To all users of the following systems: Cios VA30

Product/Trade Name:	Cios Spin, Cios Alpha, Cios Flow	EU-SRN	DE-MF-000006122
		E-mail	advancedtherapies-fsca.team@siemens-healthineers.com
UDI-DI:	04056869153506, 04056869153490, 04056869246628	Date	September, 2023
		Corrective Action ID	AX036/23/S

## Customer Safety Information (CSI) for Field Safety Corrective Action

**Subject: Fulfillment of new requirements from DIN and IEC standards for Cios VA30 Systems**

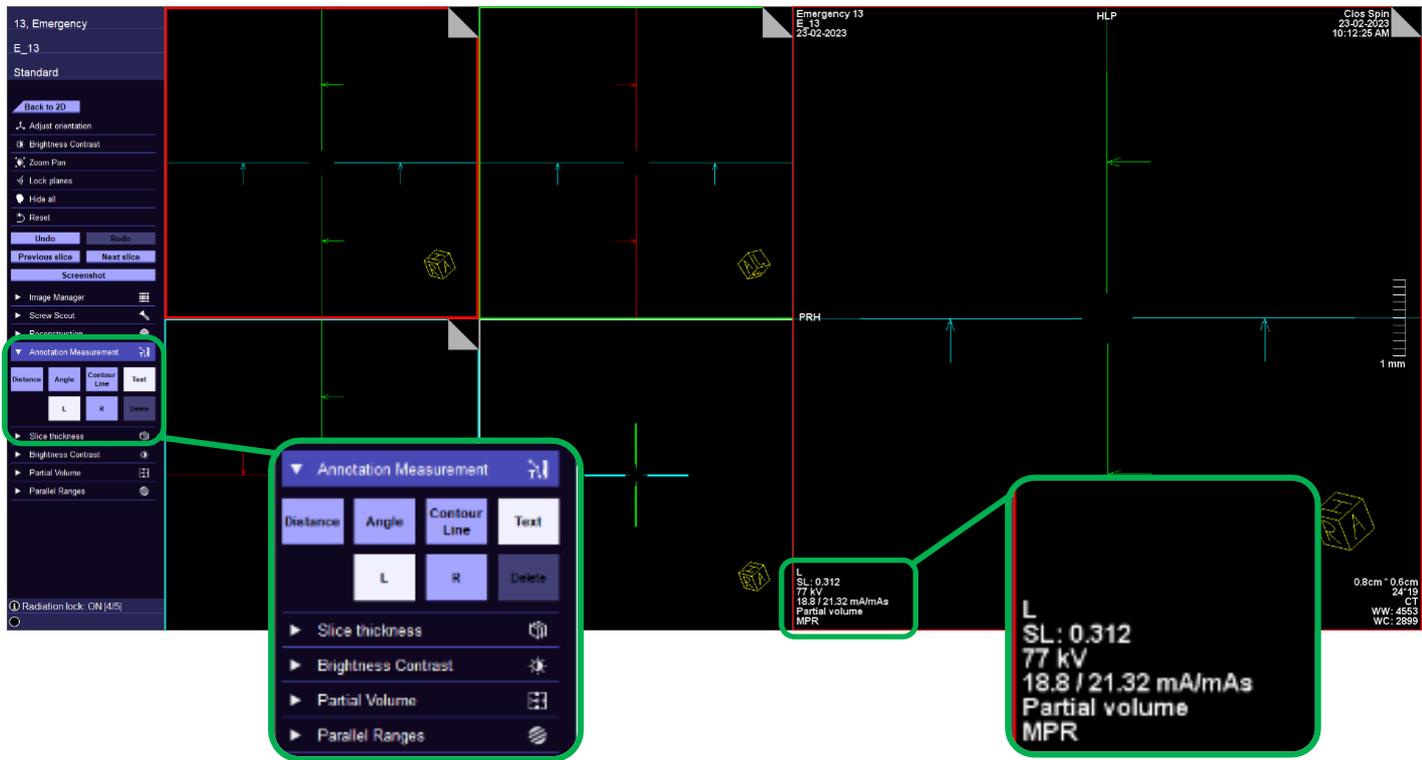
With software version VA30K, the user interface of Cios VA30 systems will be changed to consider the current standards DIN 6862-3 and IEC 60601-2-54.

**With respect to DIN 6862-3:**

In 3D mode and if patient orientation information is important in a procedure, the user can predefine the patient orientation “L/R” (left/right), and therefore “laterality” information will additionally be saved in the clinical image (see screenshot of user interface below).

In radiography modes SUB, DR, DCM as well as in 3D mode, the autostore function is selected/activated by default and cannot be deactivated by the user.
